Re: Draft Final Remedial Design/Remedial Action Work Plan, LHAAP-17 Burning Ground No. 2/ Flashing Area, Group 2, Longhorn Army Ammunition Plant, Karnack, Texas, March 2019

**Response to Comments on
Draft Remedial Design / Remedial Action Work Plan
LHAAP-17 Burning Ground No. 2 / Flashing Area, Group 2**

Reviewer: Mr. Richard Mayer, USEPA

Figure 5-3
 Estimated Radius of Influence
 for Extraction Wells
 Remedial Design/Remedial Action Work Plan, LHAAP-17
 LONGHORN ARMY AMMUNITION PLANT
 KARNACK, TEXAS

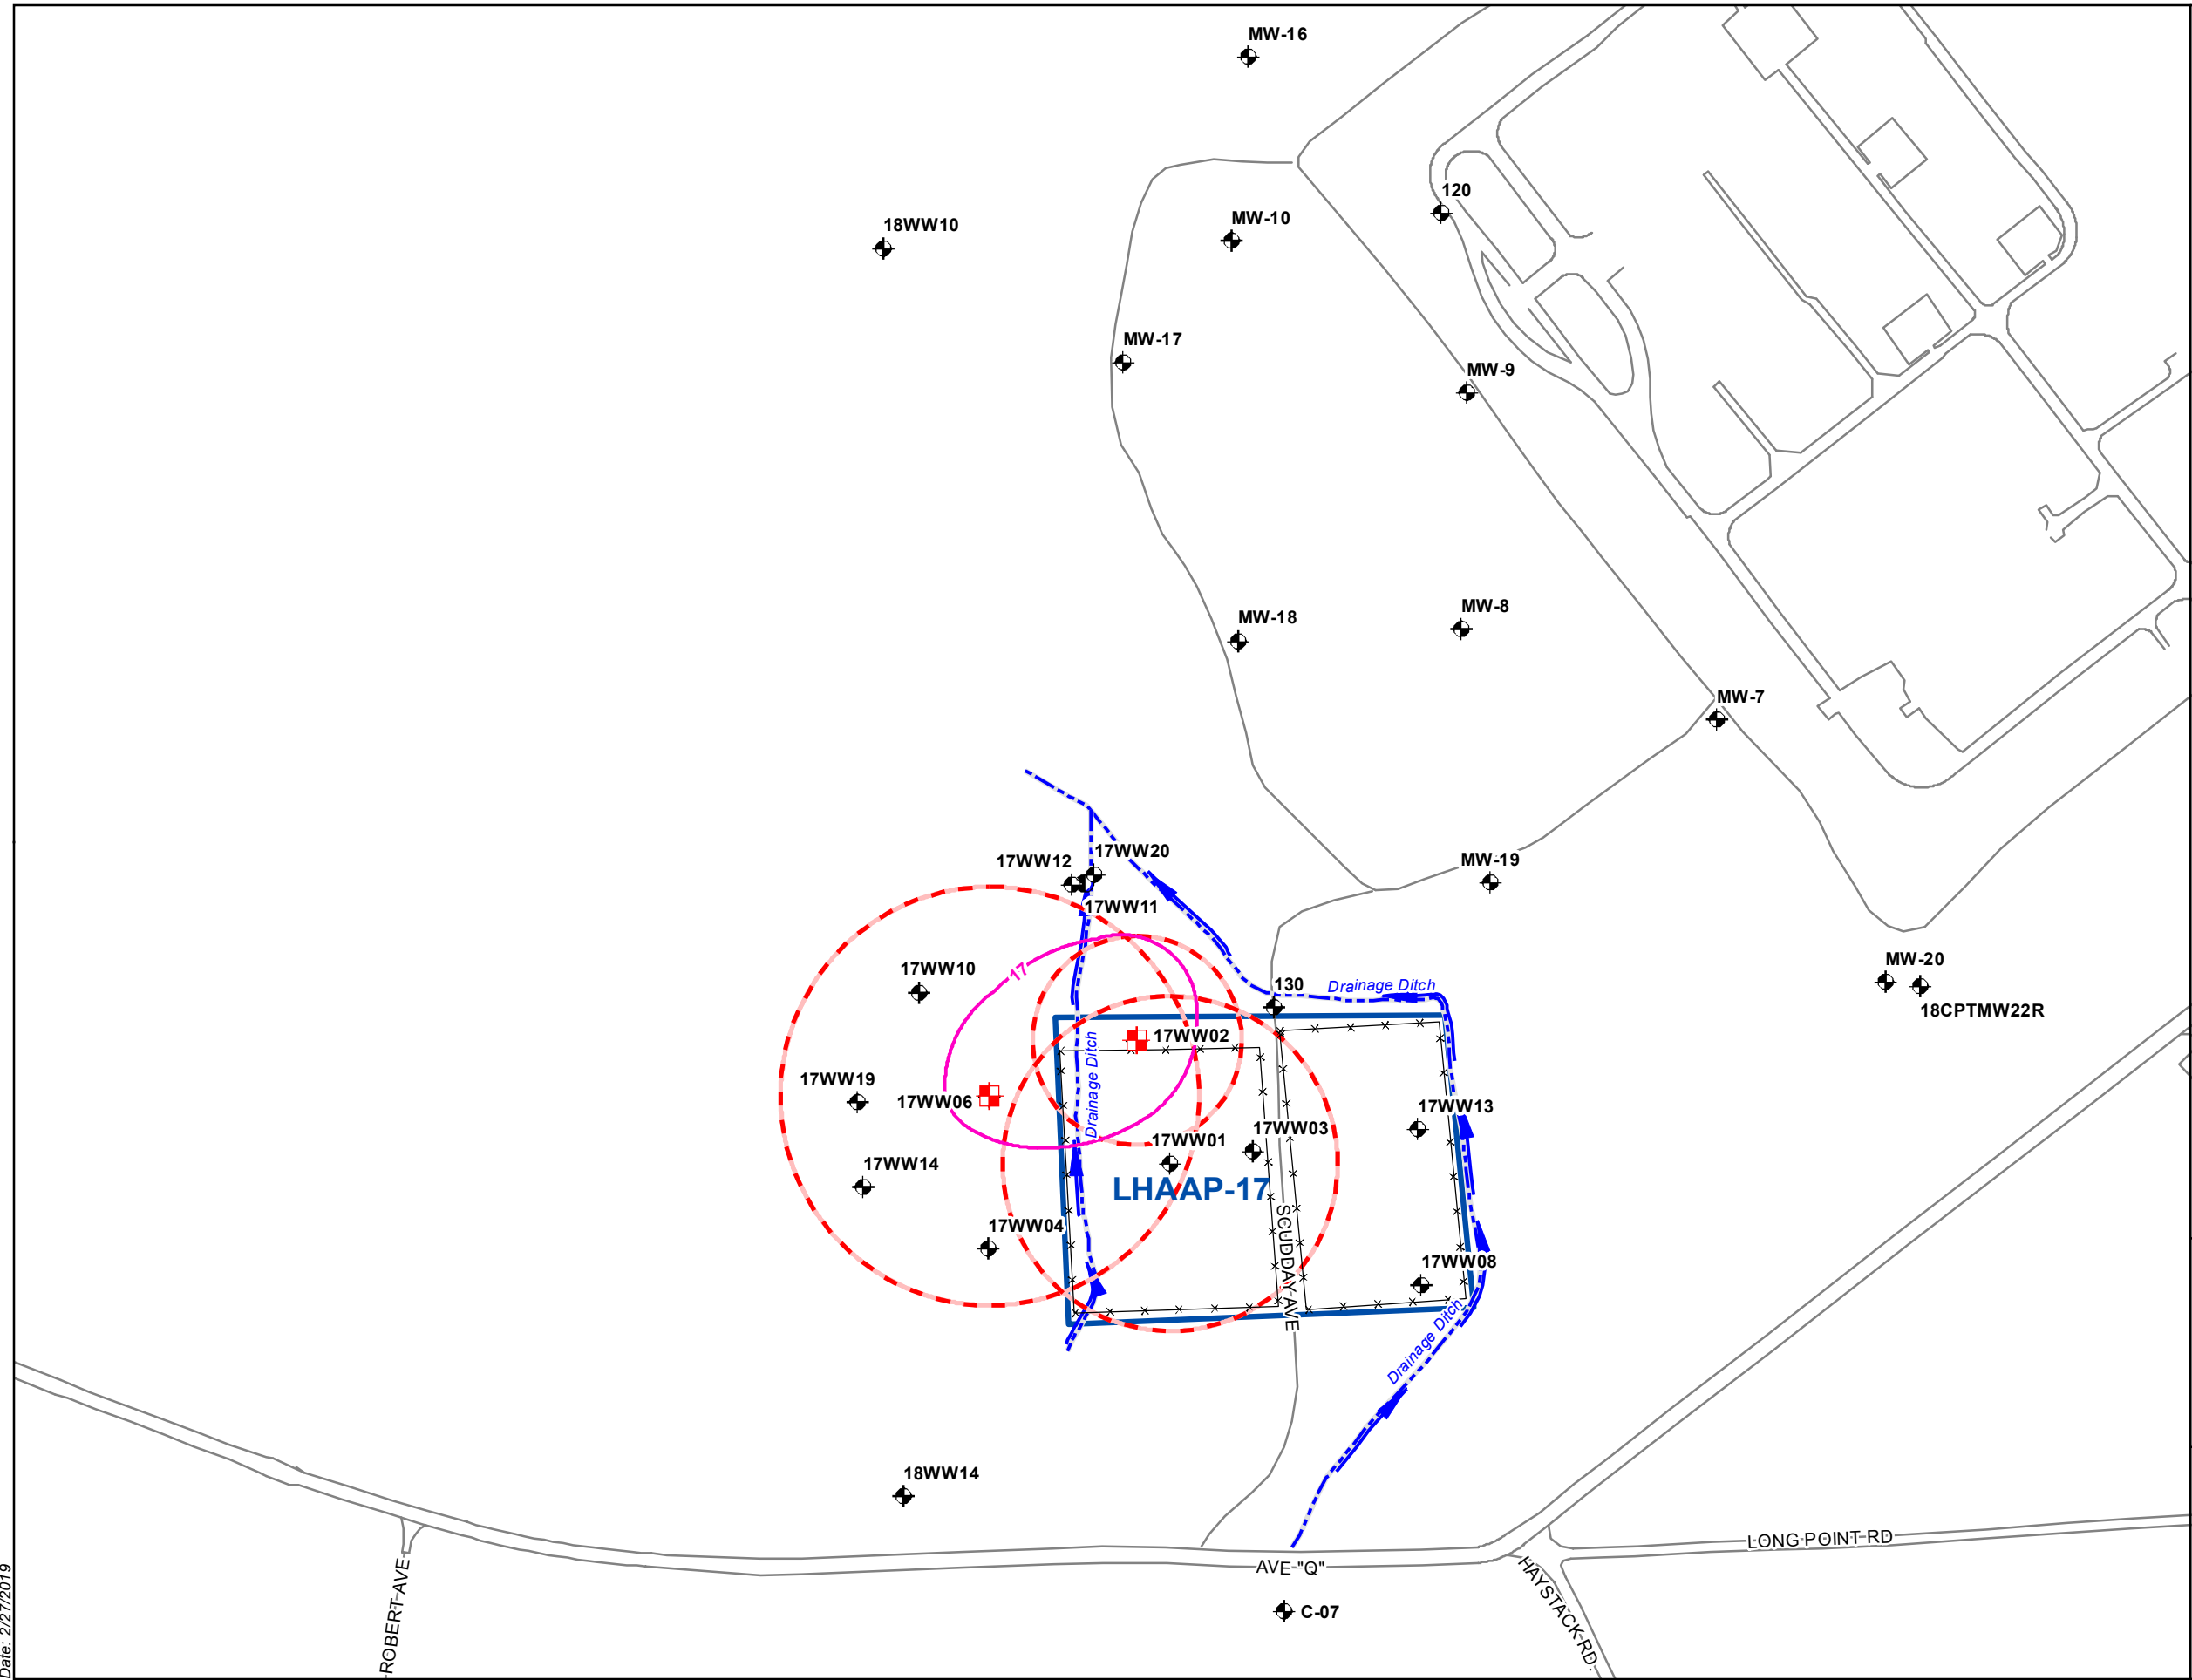
19.	Figure 5-3	Add radius of influence for 17WW01	C	An estimated radius of influence of 200 feet has been added to Figure 5-3 for 17WW01 assuming a pumping rate of 1.5 gpm.

Figure 8-1
Proposed MNA Monitoring Network
Remedial Design/Remedial Action Work Plan, LHAAP-17
LONGHORN ARMY AMMUNITION PLANT
KARNACK, TEXAS

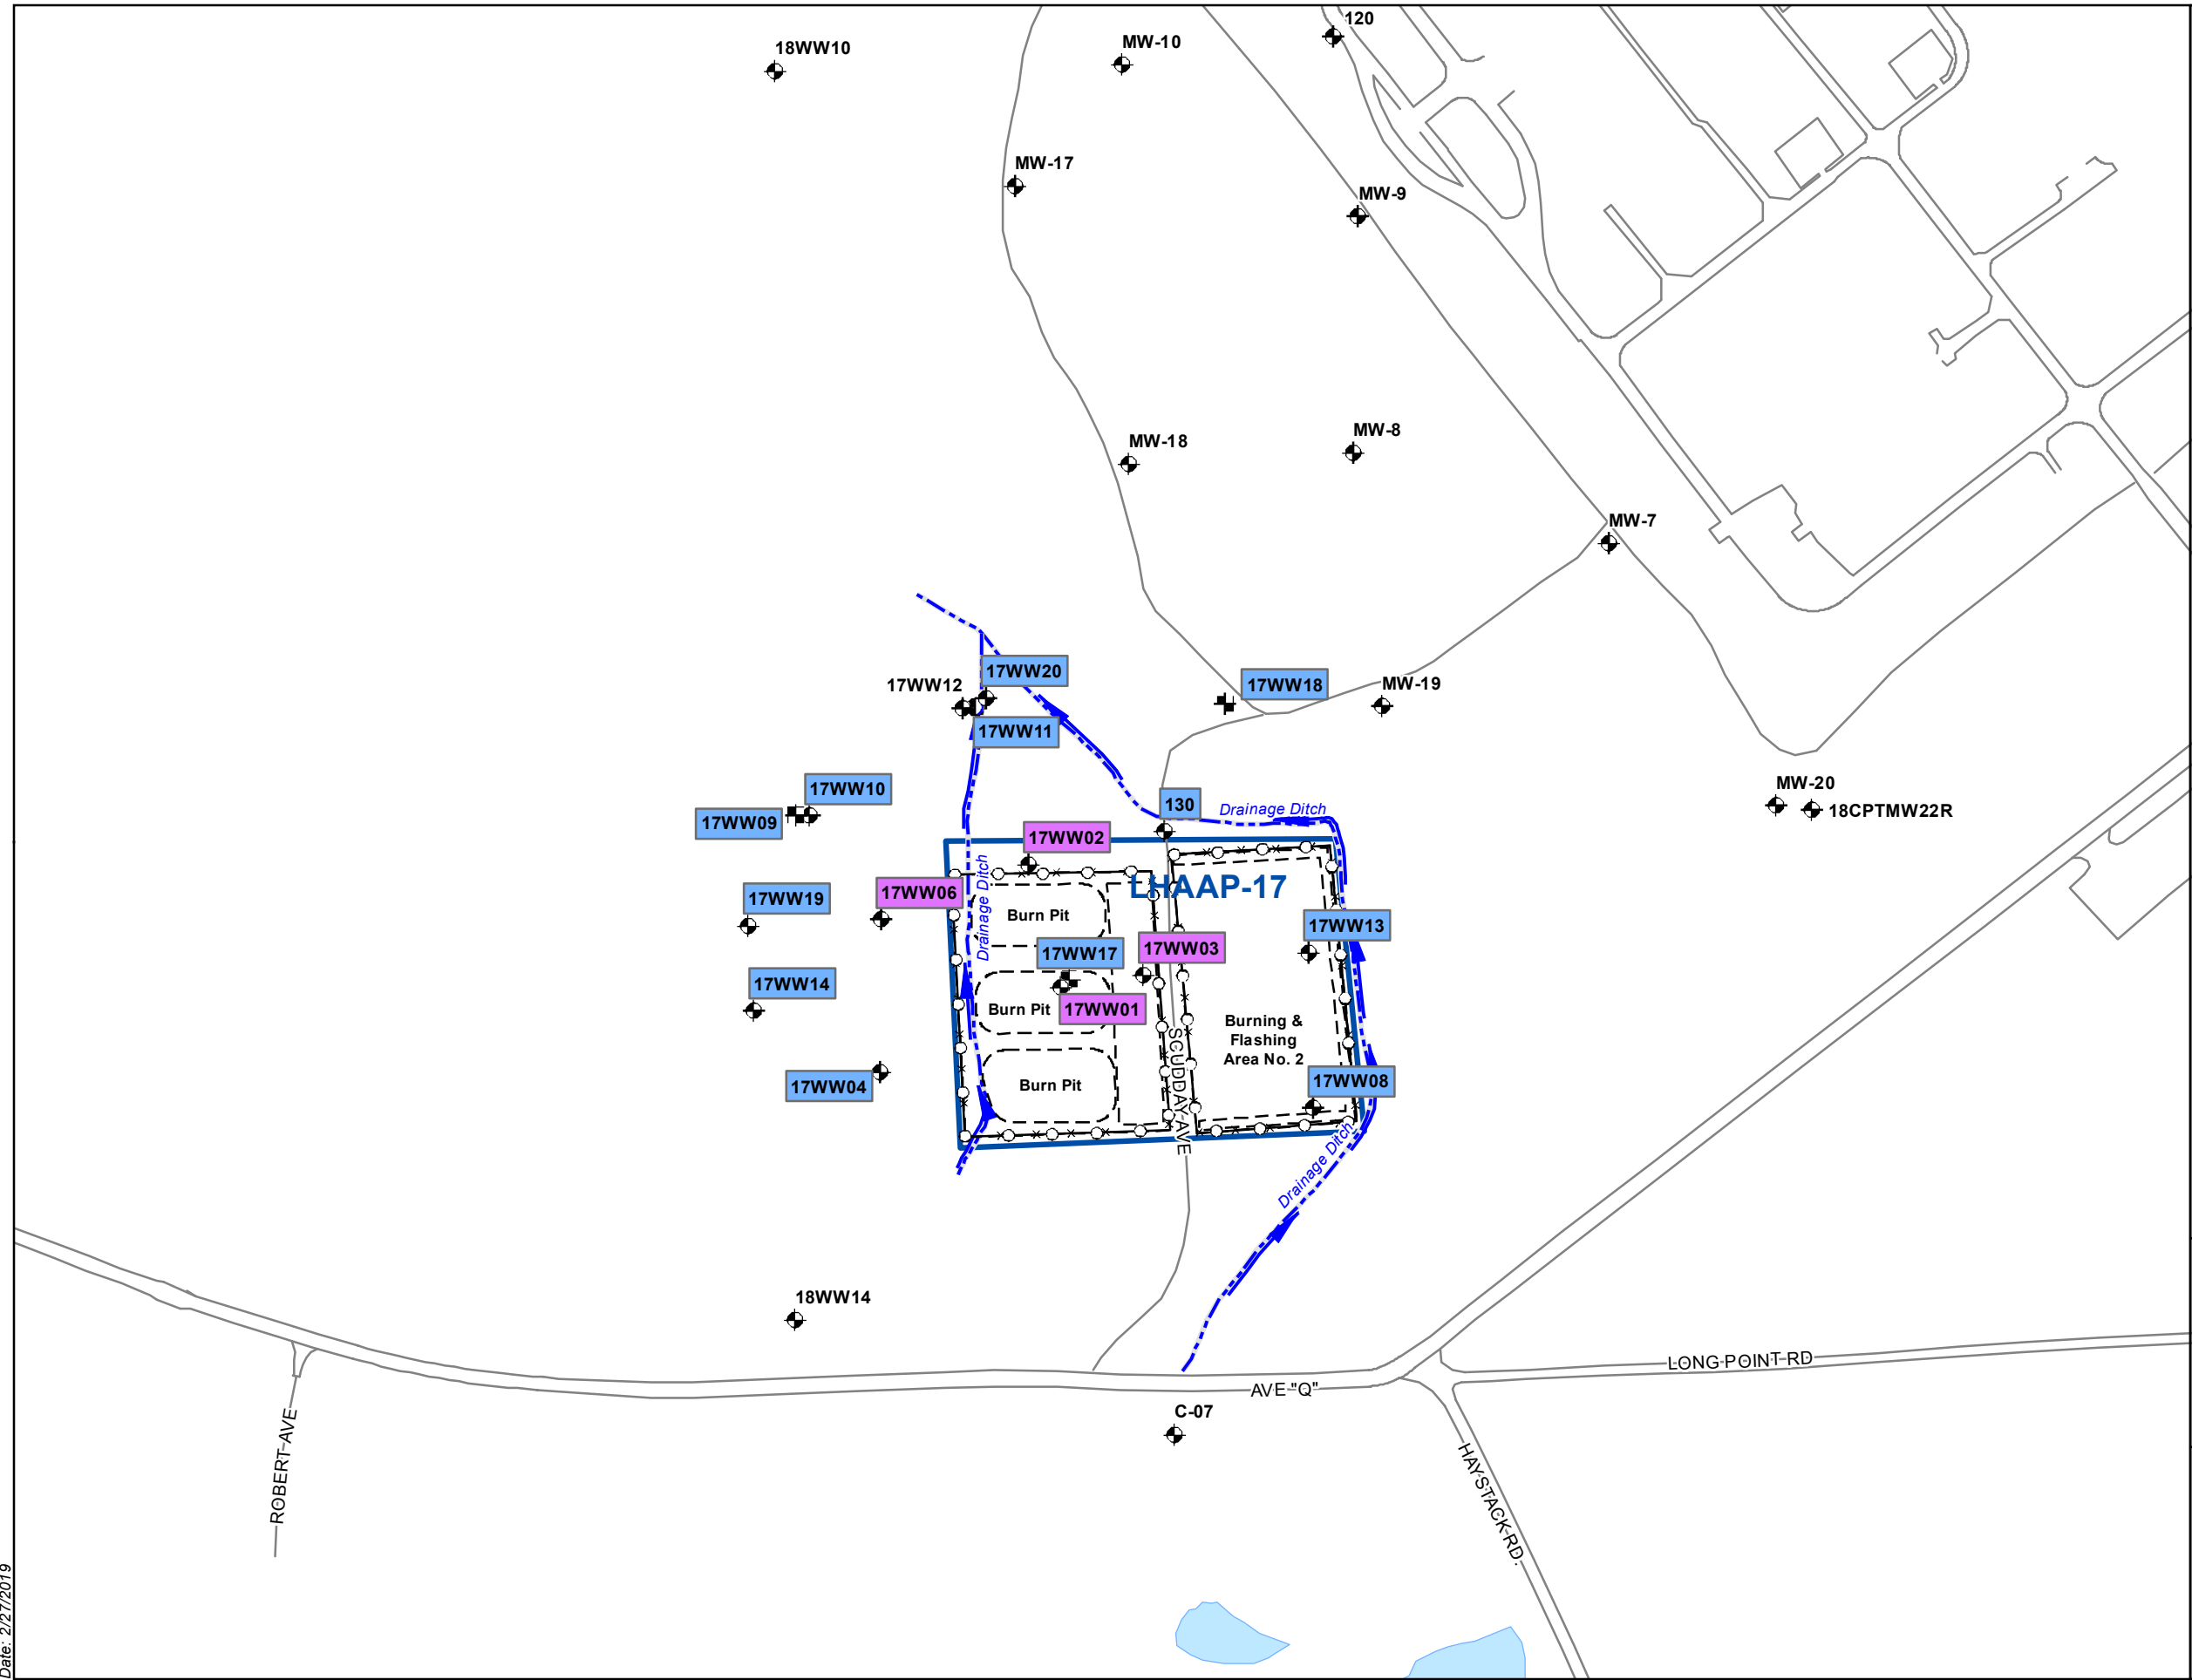
21.	Figure 7-1	Add 17WW01.	C	17WW01 has been added as a possible extraction well as requested.	
22.	Figure 8-1	Include all wells and change the color, symbol, or highlight for MNA wells. Don't hide non-MNA wells.	C	Figure 8-1 has been revised as requested.
